Access Compliance Report

Public Rights-of-Way

(Curb Ramps)

Intersection ID: N/A	Main Street: STEPHENDALE DR	Cross Street: HOOKSTON_LN	Location: NE
ADA ID: 77A7AFB8A83D	Ramp Type: Directional1	Initial Pass/Fail: Fail	Overall Compliance: No
Severity Score: 8.75			
Codes/Mitigation Info/Possible Solution		Field Measurements/Component Compliance

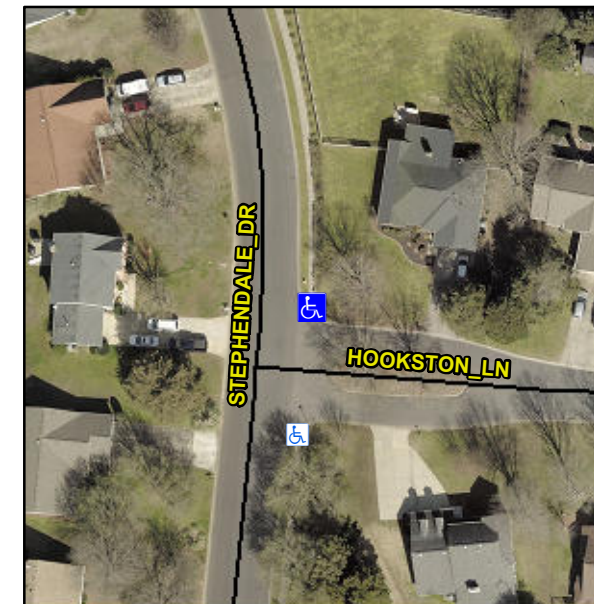
Remove & Replace Entire Ramp.

R304.5.1
